Product Change Notification

PCN-PCC-1339-2018

Business Unit	Product Line Code	Type of Change	Action	Date of Issue
PCC - PCB Connectors	AAA	Product Change Notification	Notify Distributors and Field	3/7/2018

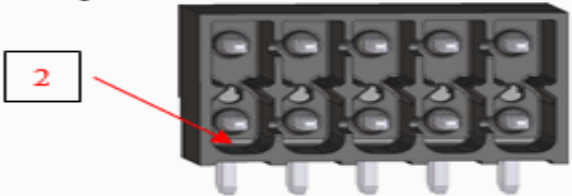
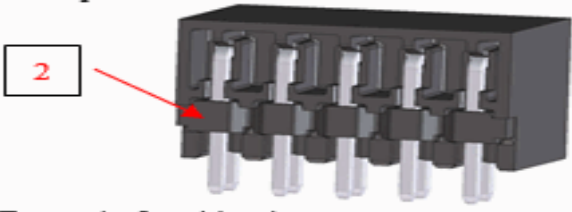
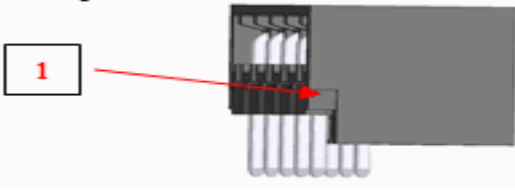
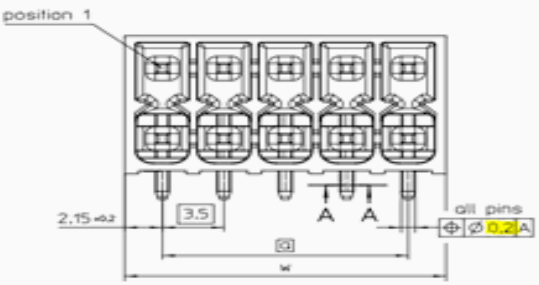
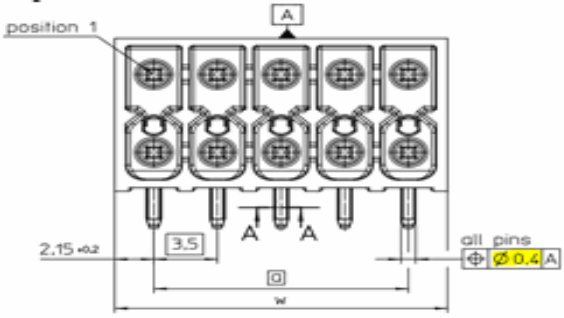
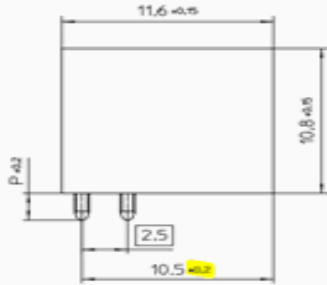
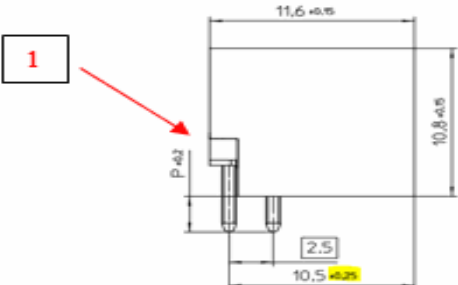
In response to high customer demand, Phoenix Contact is modifying the production process of the listed DMC 1,5 connectors from an overmolded process to a traditional pin assembly process. Changes will include: gaps within the side panels (identified as 1 in attached images); inner, non-functional dimensions (identified as 2 in attached images); certain tolerances will be increased (highlighted in yellow on attached images), but will still meet the through-hole-reflow standard IEC 61760-3. The technical performance data, materials, approvals, PCB layout, and external dimensions will not change. New versions are expected to begin shipping July 2, 2018, and will be identified by a change to the version code (V/C) as noted on the attached spreadsheet.
